SUBJECT APPROVED PROJECT CONCEPT REPORT

Cumming Park and Ride Lot

Project Number: MSL-0003-00(541)
PI No. 0003541
County: All

To: Darell Richardson, GDOT
From: David McKinney, PE
Date: November 14, 2004
File: 15284002
Copy: Emmy Montanye-URS
Brian Bolick-URS
Subject: TELEPHONE CONVERSATION MINUTES - Cumming Park & Ride Lot - GRТА

DRAWING NO.
5-01

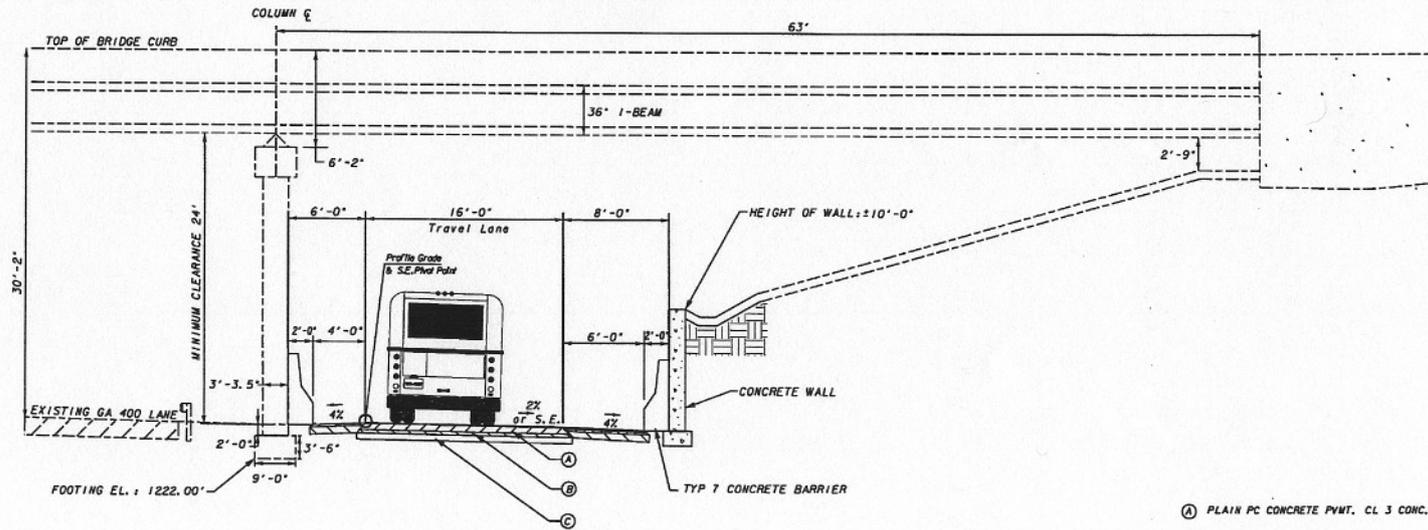
- I. Items discussed are as follows:
 - A. **Location Map does not have the appropriate project number.**
 - B. **Bus Ramp cross-section shows "Maximum Clearance = 24" under the Old Atlanta Bridge. This is misleading. Should be "Minimum Clearance = 24".**

- C. **Pavement depths should be included on Bus Ramp cross sections**
 - D. **Estimate included with the revised report does not appear to reflect changes made to the design resulting from the Concept Meeting Comments:**

2. **Pavement design should be:**
 - 1.5" Asphalt Surface Layer
 - 2" Asphalt Binder Layer
 - 3" Asphalt Base Layer
 - 8" GAB layer
